Access Compliance Report Public Rights-of-Way (Curb Ramps)

Main Street: FAIRHAVEN_AVE Cross Street: PALOMAR_WAY Location: NW

ADA ID: RPAT211022091816 Ramp Type: Type 4 - Parallel Initial Pass/Fail: Fail Overall Compliance: No Severity Score: 30

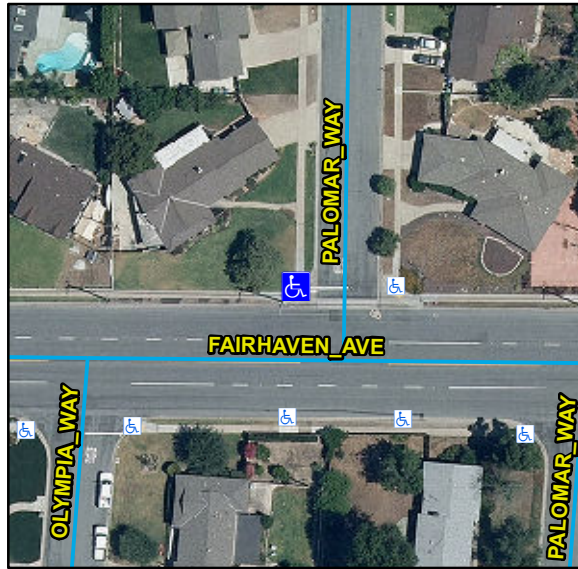
Compliance	Description	Data	Compliance	Description	Data
N/A	Ramp Length LT (in)	103	N/A	Ramp Length RT (in)	114
Yes	Ramp Width LT (in)	48	Yes	Ramp Width RT (in)	72
Yes	Ramp Run Slope LT (%)	2.5	Yes	Ramp Run Slope RT (%)	7.1
No	Ramp Cross Slope LT (%)	7.7	Yes	Ramp Cross Slope RT (%)	1.8
N/A	Landing Present	N/A	N/A	DWS Provided	N/A
N/A	Landing Length (in)	N/A	N/A	DWS Contrast	N/A
N/A	Landing Width (in)	N/A	N/A	DWS Length (in)	N/A
N/A	Landing Run Slope (%)	N/A	N/A	DWS Full Width	N/A
N/A	Landing Cross Slope (%)	N/A		DWS Offset Type	N/A
N/A	Landing Movement Obstructed?	N/A	N/A	DWS Offset Left (in)	N/A
	Landing Movement Type	N/A	N/A	DWS Offset Right (in)	N/A
N/A	Landing Shared	N/A			
N/A	Clear Space	Yes			
N/A	Clear Space To Crosswalk (in)	N/A			
N/A	Marked Crosswalk 1	No	N/A	Marked Crosswalk 2	No
	Crossing 1 Direction	S		Crossing 2 Direction	E
	Marked Crosswalk 1 Width (in)	N/A		Marked Crosswalk 2 Width (in)	N/A

Remove & Replace Curb Ramp With Two New Directional Ramps or Equivalent.
